Intel[®] Pentium[®] M Processor and Intel[®] 855PM Chipset DDR 333/266/200 MHz Platform

Design Guide Update

April 2005

Document Number: 253479-003

Figure 91. Data Signal Group (SDQ[71:0], SDQS[8:0]) Routing Topology – PC2700, PC2100 and PC1600 Compliant

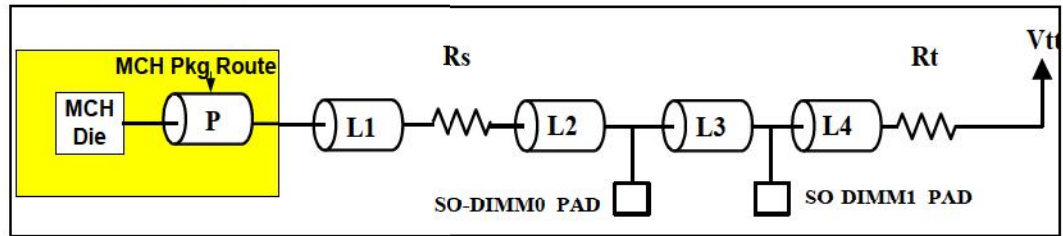
While the maximum length of L1, L2, L3, and L4 remains unchanged from previous revisions of this design guide, the maximum overall length allowed from the MCH-M to the second SO-DIMM ($L1 + R_s + L2 + L3$) for PC2700 support is limited to 4.5 inches. **This represents a reduction of 1.0 inches compared to that allowed for PC2100 and PC1600 design guidelines.** As a result, platforms based on current PC2100 and PC1600 layout guidelines may require a reduction in trace lengths of up to 1.0 inches, in order to meet the PC2700 maximum data signal group length requirements.

L1	L2	L3	L4	Rs	Rt	L1 + Rs + L2 + L3
DDR Data Signal Group (for platform supporting PC2700, PC2100, PC1600 DDR SDRAM)	Min = 0.5" Max = 3.75"	Min = 0" Max = 0.75"	Min = 0" Max = 1.0"	Min = 0" Max = 0.8"	22.6 Ω ± 1%	54.9 Ω ± 1%	Min = 0.5" Max = 4.5"
DDR Data Signal Group (for platform supporting PC2100 and PC1600 DDR SDRAM)	Min = 0.5" Max = 3.75"	Min = 0" Max = 0.75"	Min = 0" Max = 1.0"	Min = 0" Max = 0.8"	22.6 Ω ± 1%	54.9 Ω ± 1%	Min = 0.5" Max = 5.5"

Figure 1. Recommended Topology for Coexistence Traces

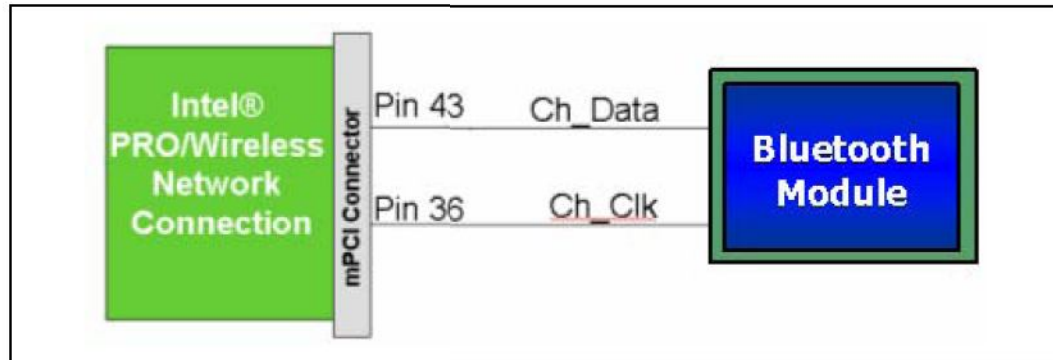
Two PCB traces shall be used to carry channel number and clock signals between Bluetooth and Intel PRO/Wireless 2100. Although these traces do not need to match any length, width or impedance constraints a typical width of 5 mils and spacing of 5 mils is recommended. Pin # 43 of the mPCI connector needs to be routed to the Channel_Data signal of the Bluetooth module. Pin # 36 of the mPCI connector needs to be routed to the Channel_Clock signal of the Bluetooth module. The Channel_Data and Channel_Clock pins on the Bluetooth module are vendor specific. Please refer to the corresponding Bluetooth module vendor for this information. The traces between Callexico and Bluetooth are a point-to-point connection and do not require any intervening components.
